Agenda
Village of Arlington Heights
Design Commission
Community Room, 3rd floor

Item: DC#19-050 - McDonalds - 45 E. Golf Rd. - Commercial

STAFF DESIGN COMMISSION REPORT

Project Name: McDonald's
Project Address: 45 E. Golf Road
Prepared By: Steve Hautzinger

SHEET TITLE:
EXTERIOR ELEVATIONS

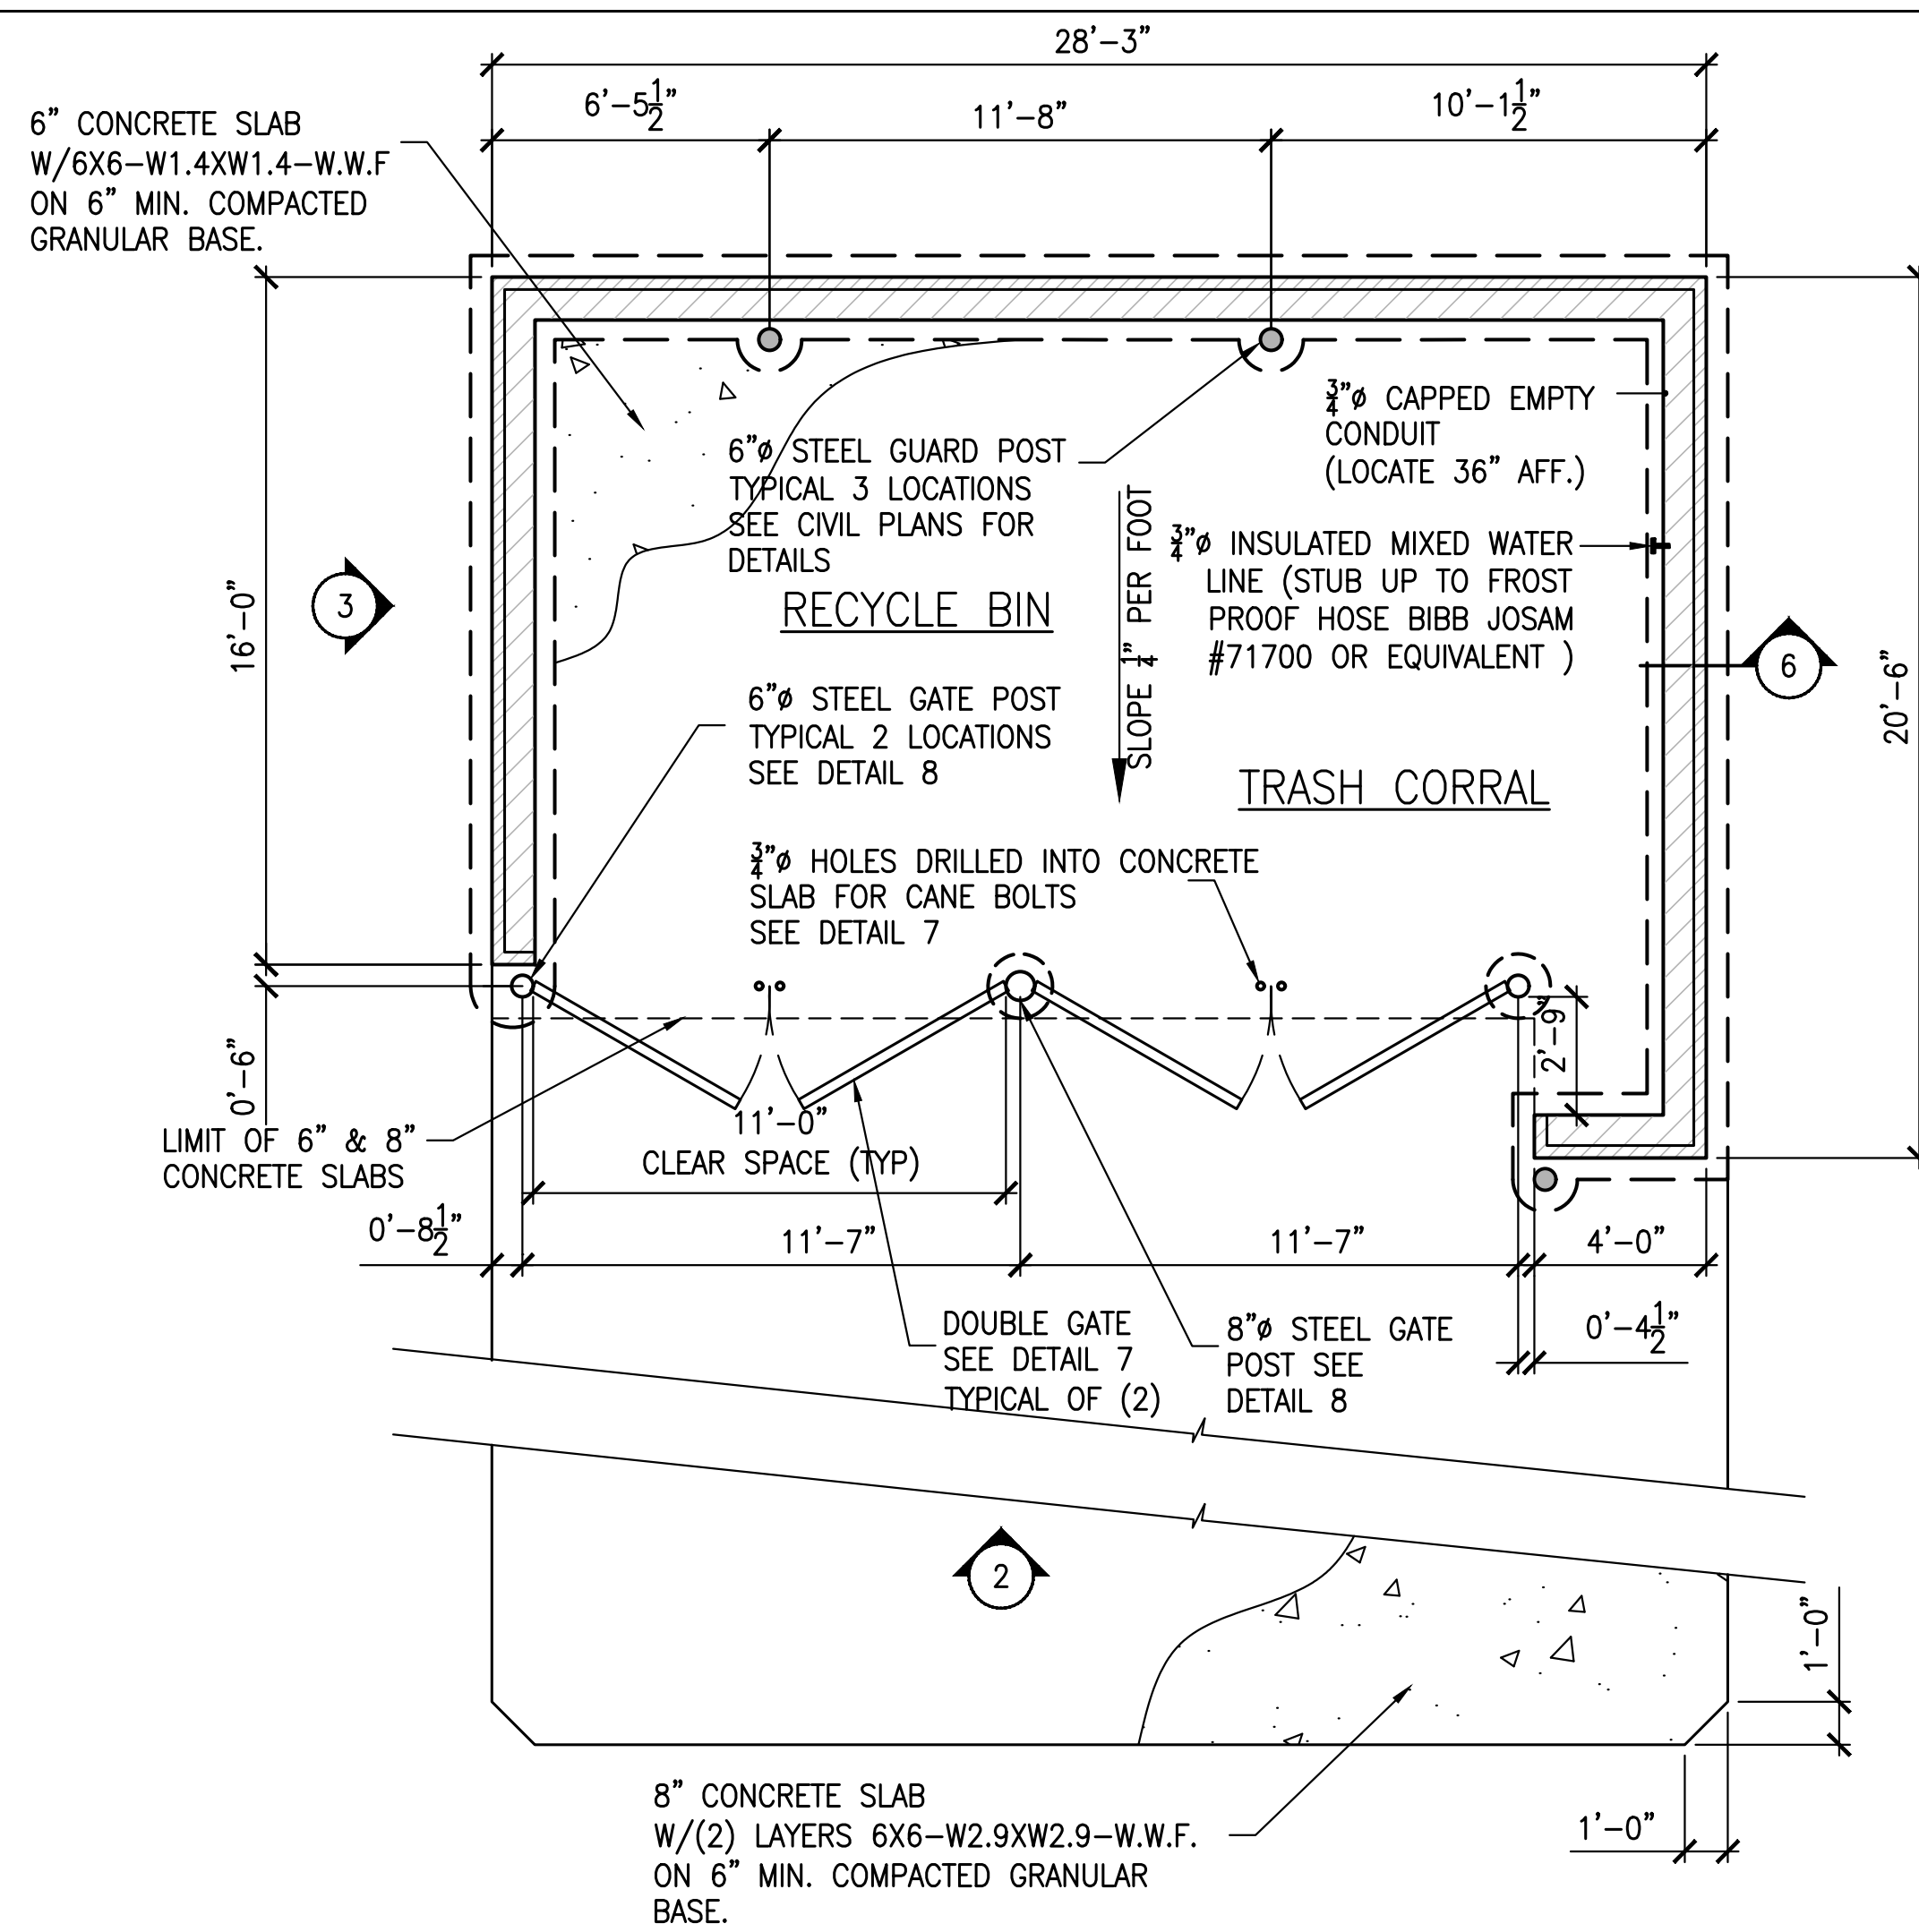
The proposed exterior design is consistent with McDonald's current prototype standards. The existing mansard roof will be removed in its entirety and replaced with new EIFS walls. Fiber cement panels are proposed to highlight the building entrances, and corrugated metal is proposed as an accent at the top of the walls. The existing face brick and clear anodized aluminum storefronts will remain with minor modifications as needed.

The proposed wall signs are generally consistent with other McDonald's restaurants in Arlington Heights, with signage on the front wall and on the side wall above the entrance. However, this property is located in an O-T Zoning District where wall signage is not allowed. The existing building has one wall sign and one ground sign which were approved by variation in 1996. The new design includes two additional wall signs (three total) and a canopy sign which are not allowed. The existing ground sign will remain.

The petitioner will either need to revise the proposed signage to comply with the previously approved variations, or request additional variations from Chapter 30 for the new signs to be reviewed based on hardship.

1. Either revise the proposed signage to comply with the previously approved variations, or request additional variations from Chapter 30 for the new signs.
2. This review deals with architectural design only and should not be construed to be an approval of, or to have any other impact on, any other zoning and/or land use issues or decisions that stem from zoning, sign code or building or any other reviews. In addition to the normal technical review, permit drawings will be reviewed for consistency with the Design Commission and any other Commission or Board approval conditions. It is the architect/owner/builder's responsibility to comply with the Design Commission approval and ensure that building permit plans and sign permit plans comply with all zoning code, building code and sign code requirements.

ELEVATIONS

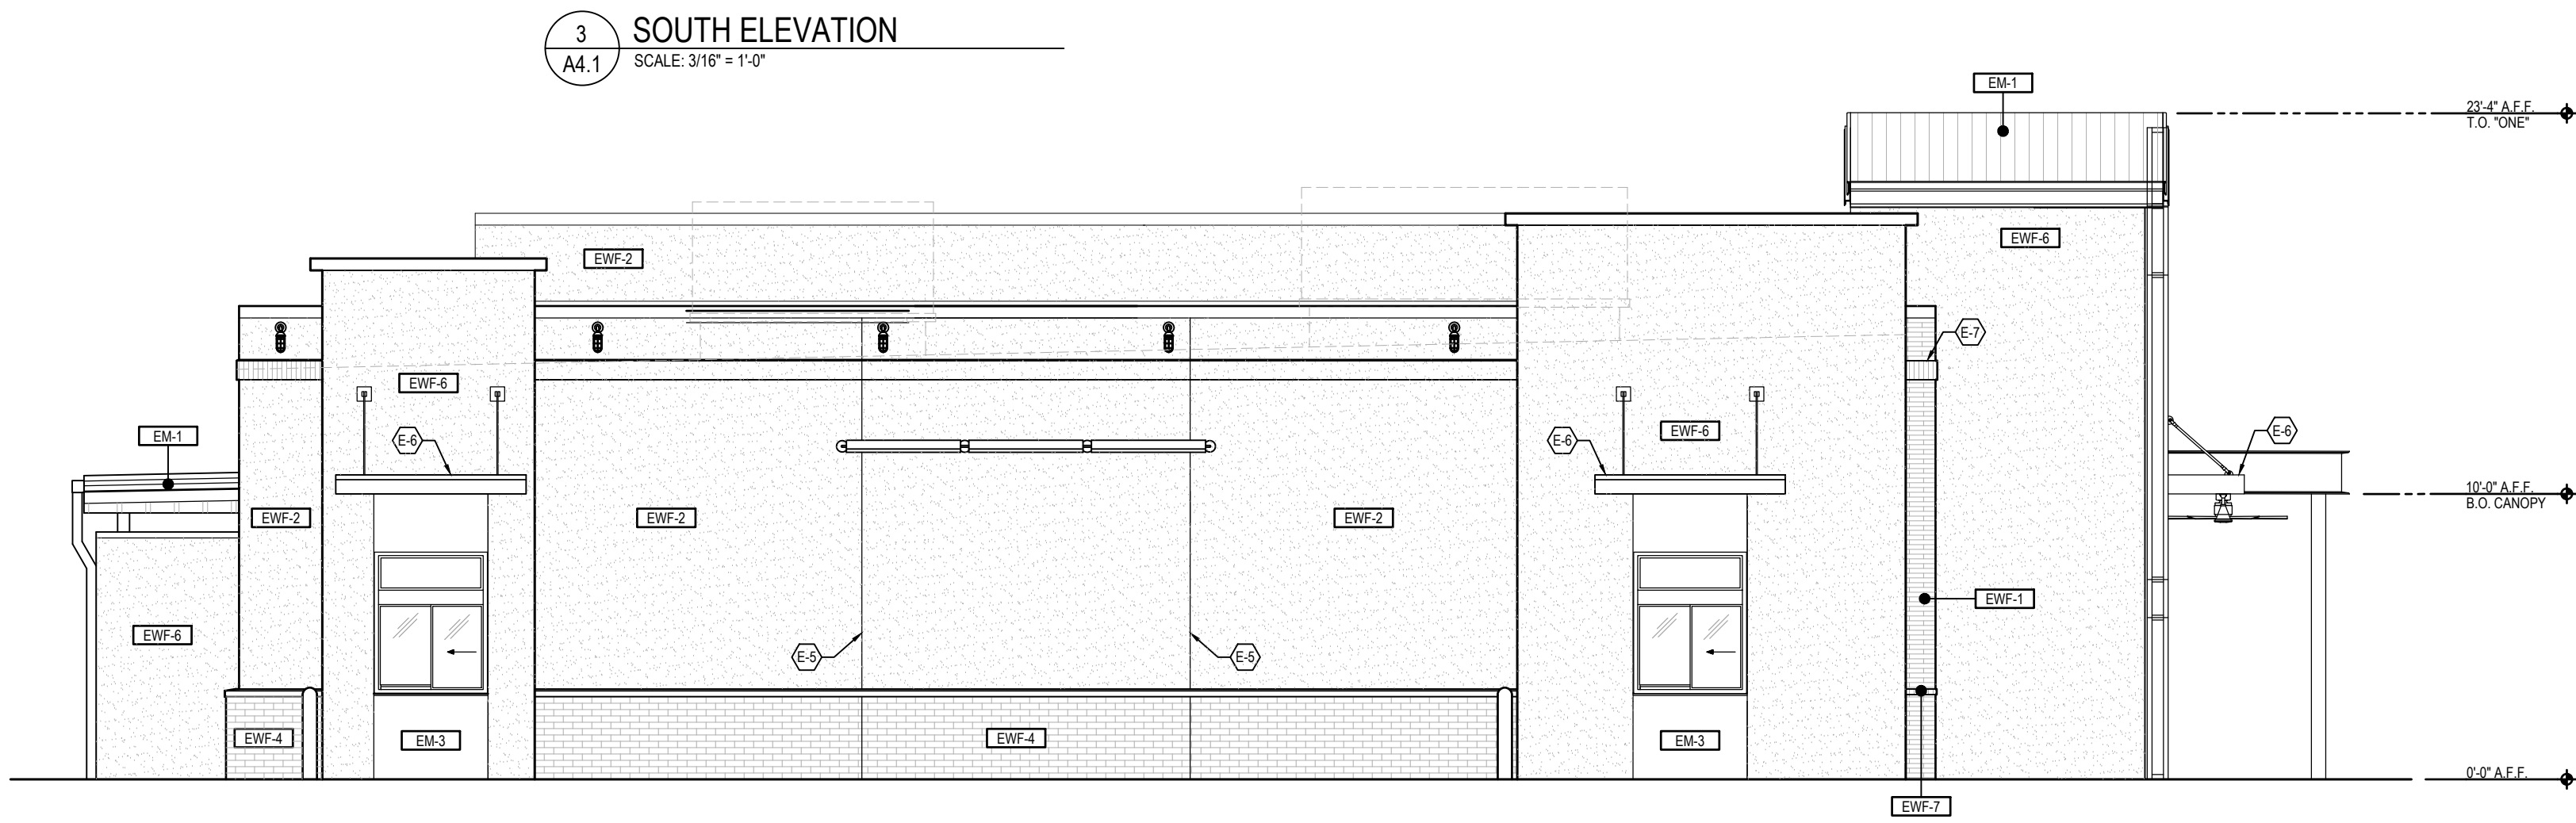
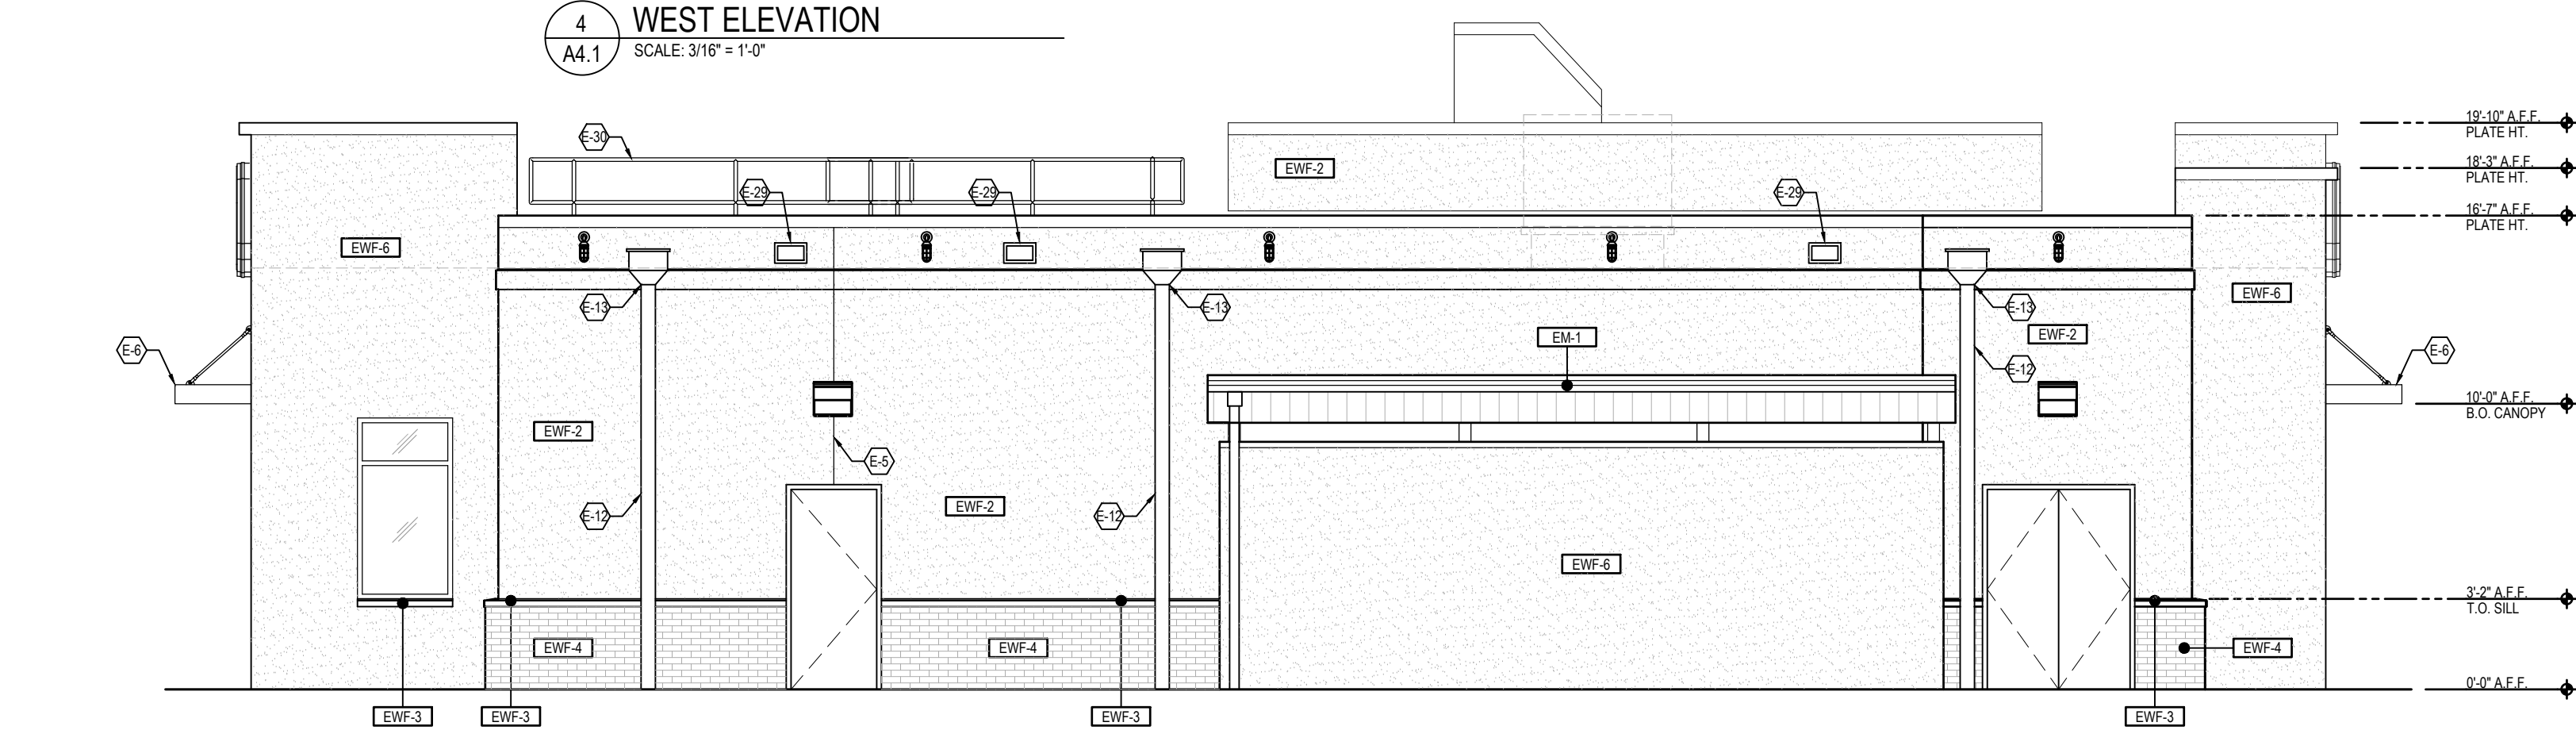
1. Explore alternative solutions to eliminate the rooftop guard rail.
2. Either revise the proposed signage package to comply with Chapter 30 sign code, or request sign variations.
3. This review deals with architectural design only and should not be construed to be an approval of, or to have any other impact on, any other zoning and/or land use issues or decisions that stem from zoning, sign code or building or any other reviews. In addition to the normal technical review, permit drawings will be reviewed for consistency with the Design Commission and any other Commission or Board approval conditions. It is the architect/owner/builder's responsibility to comply with the Design Commission approval and ensure that building permit plans and sign permit plans comply with all zoning code, building code and sign code requirements.
